UNITED STATES PATENT AND TRADEMARK OFFICE

APPLICATION NO.	FILING DATE	FIRST NAMED INVENTOR	ATTORNEY DOCKET NO.	CONFIRMATION NO.
10/796,754	03/08/2004	Sun-Ha Hwang	4591-393	4368

Office Action Summary	Application No. 10/796,754	Applicant(s) HWANG ET AL.	
	Examiner Su C. Kim	Art Unit 2823

DETAILED ACTION

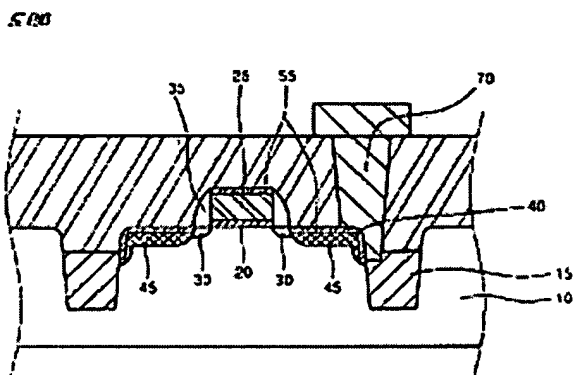
Baek discloses a semiconductor process as claimed. **See all FIGS** where Baek teaches the following limitations

4. With respect to claim 1, Baek discloses a method of fabricating a semiconductor substrate, comprising:

forming an isolation layer **15** in a substrate **10** of first conductivity type, the isolation layer formed with an outline to define an active region (please note that active region is between isolation regions);

recessing a region of the device isolation layer **15** and exposing a portion of the first conductivity type material under the impurity diffused region; and

forming a salicide layer **55** covering the impurity diffused region and covering the portion **40** of the first conductivity type material exposed by the recess.

2. With respect to claim 2, Baek discloses the recess **15** is formed by etching to a depth deeper than a depth of the impurity diffused region.

Fig. 7

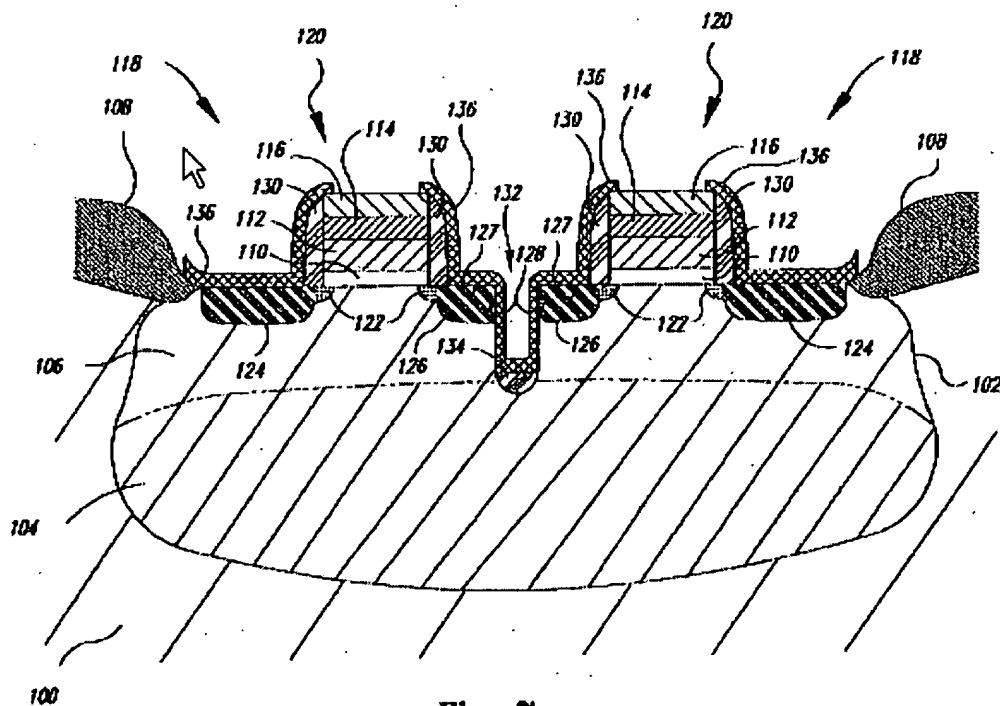
Violette disclose a semiconductor process as claimed. See FIG. 1-10 where Violette teaches the following

6. With respect to claim 5, Violette discloses that a method of fabricating a semiconductor device, comprising:

forming a device isolation layer **108** in a predetermined region of a substrate **100** of first conductivity type (doped P-type, column 3, line 10) to define an outline to an active region;

forming a gate pattern **120** crossing the active region;

forming a source/drain region **124 & 122** of second conductivity type in the active region (N-type, column 3, line 55) at both sides of the gate pattern;

siliciding **136** a surface of the source/drain region of second conductivity type and a surface of the substrate of first conductivity type exposed by the recess.

7. With respect claim 6, Violette discloses the method of claim 5, in which the forming the recess comprises etching the device isolation layer **108** to a depth deeper than the thickness of the source/drain region of second conductivity type.
